Building 88 Fire Door System Upgrade
Project No. GSD126438

REQUEST FOR QUOTATION #GSD126438
Building 88 Fire Door & Hardware Installations

Addendum #1: Revision of Specifications and Clarification

Addendum #2: Technical Questions and Answers

BASEMENT FLOOR PLAN

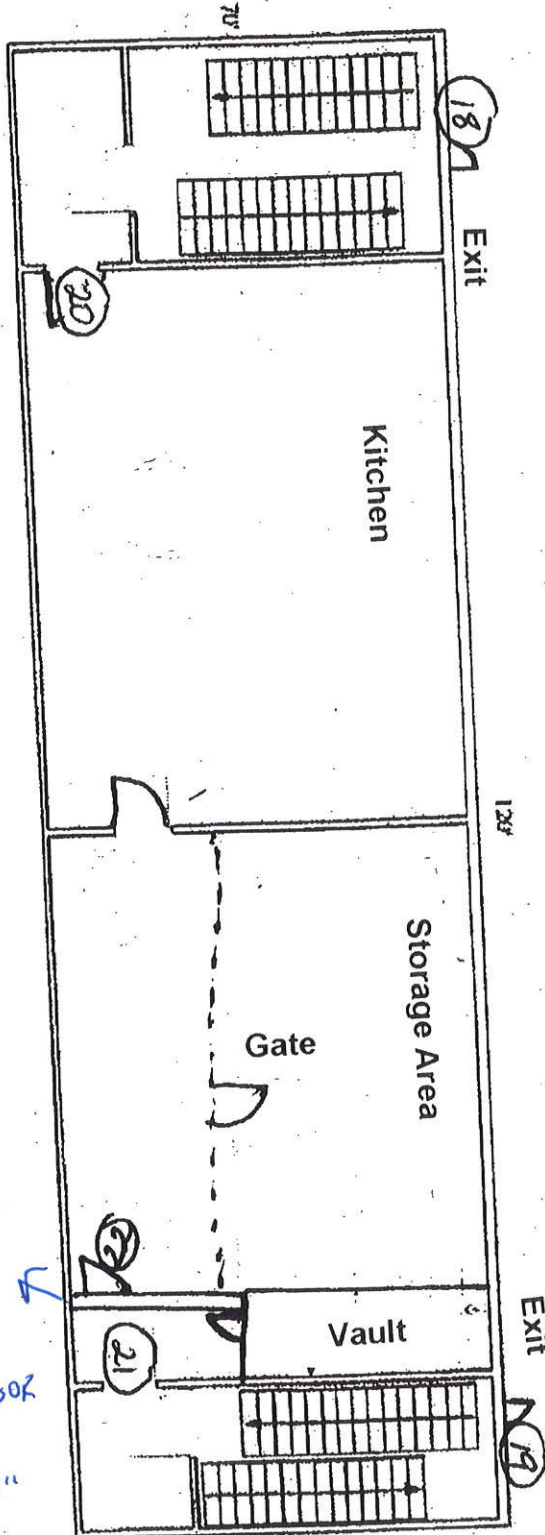
#22
5/8" sheetrock
up to deck
Add Door
LH
3'-0 6/8"

SECOND FLOOR PLAN

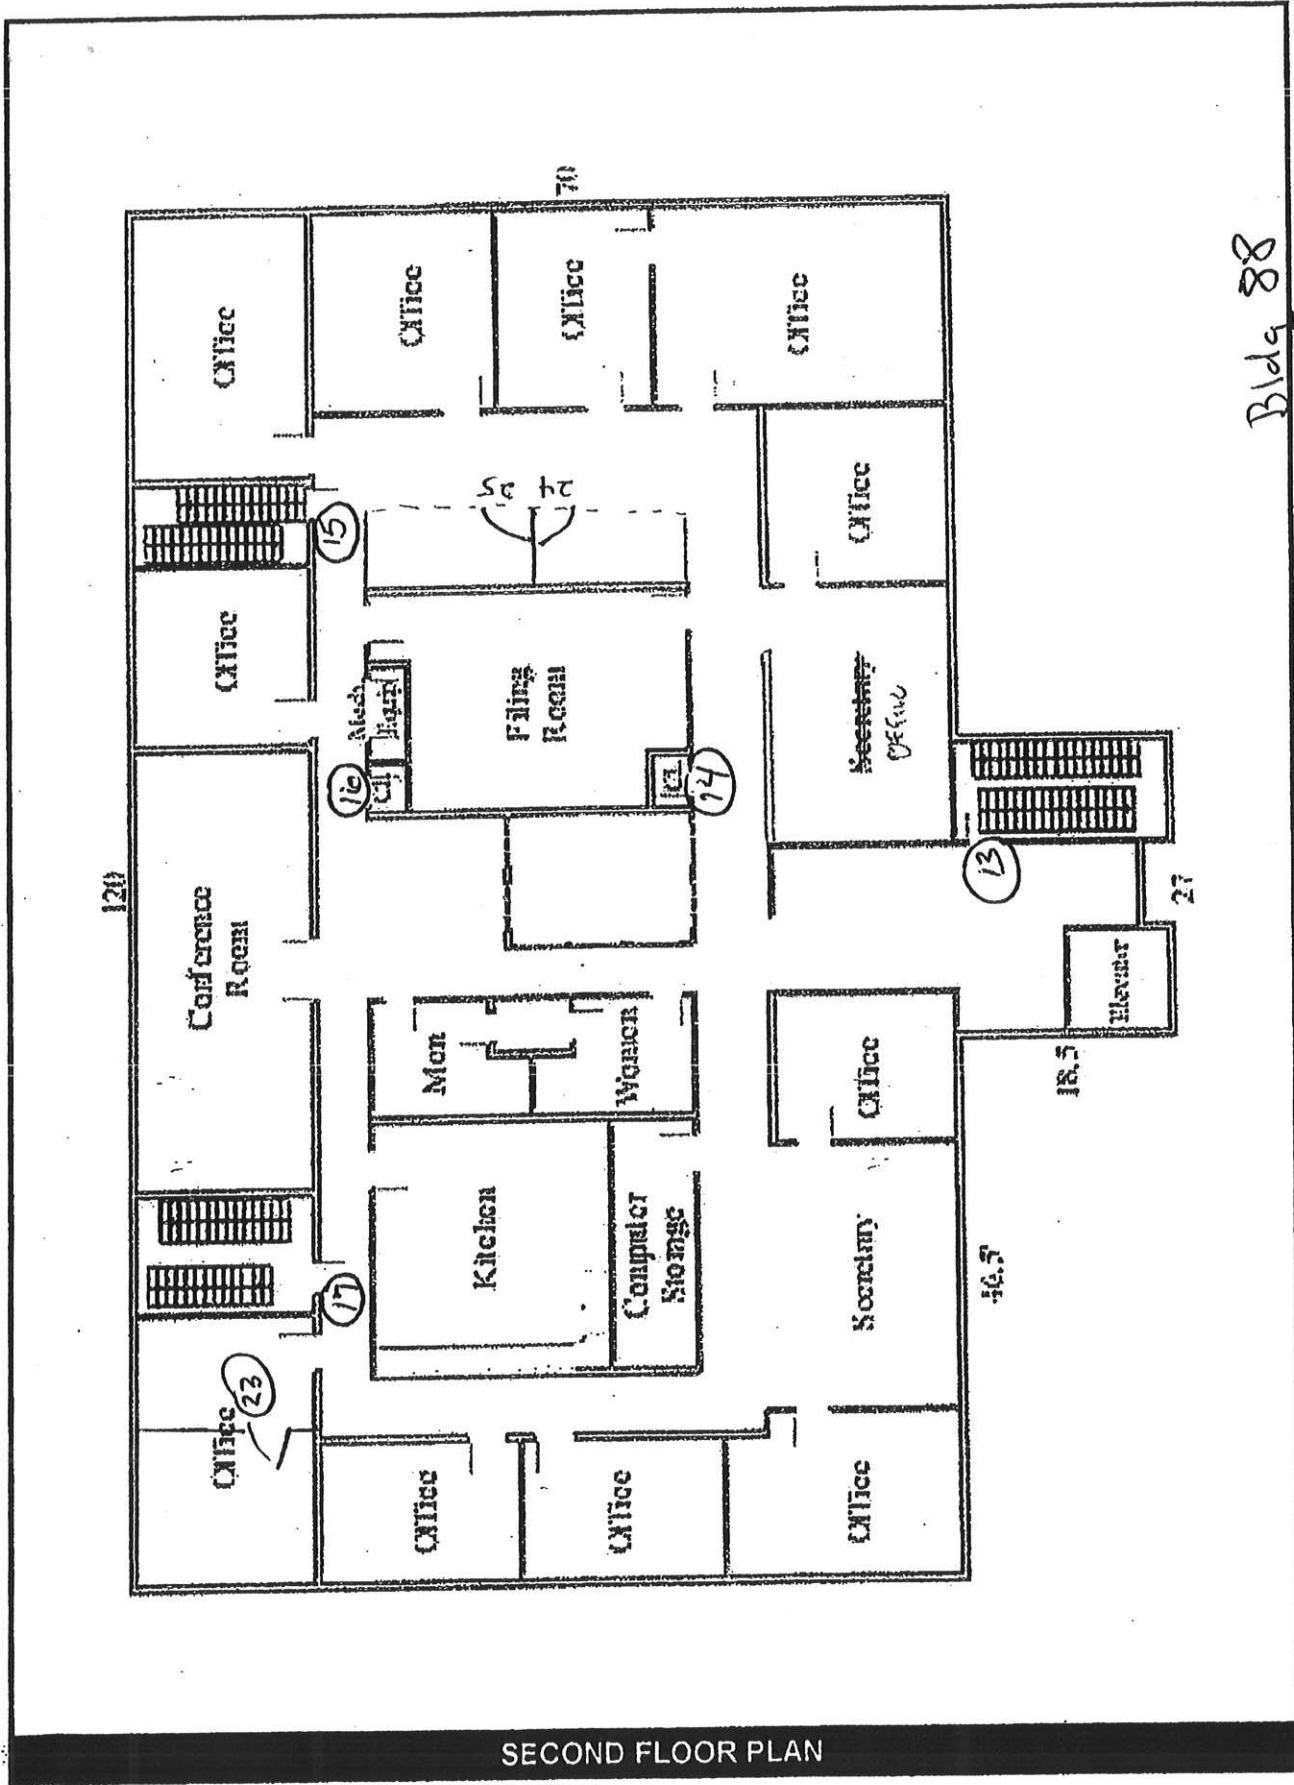
Please revise the specifications to include three (3) additional locations for door installations, all per the attached Revised Second Floor Drawing:

#23: install new frame and door in rough opening (38.5" x 82"): 3-0 single office left hand, 90 minute, style and color to match office entrance, install matching wood base, crown to match existing décor, finish and match paint as required.

#24: install new frame and door in rough opening (38.5" x 82"): 3-0 single office left hand, 90 minute, style and color to match office(s), install matching wood base, crown to existing décor, finish and match paint as required.

#25 3-0: install new frame and door in rough opening (38.5" x 82"): single office left hand, 90 minute, style and color to match office(s) install matching finish and match paint as required.

Project will also include installing matching trim (cove base, crown molding) on both sides of the partition wall between the offices with doors #24 and #25.
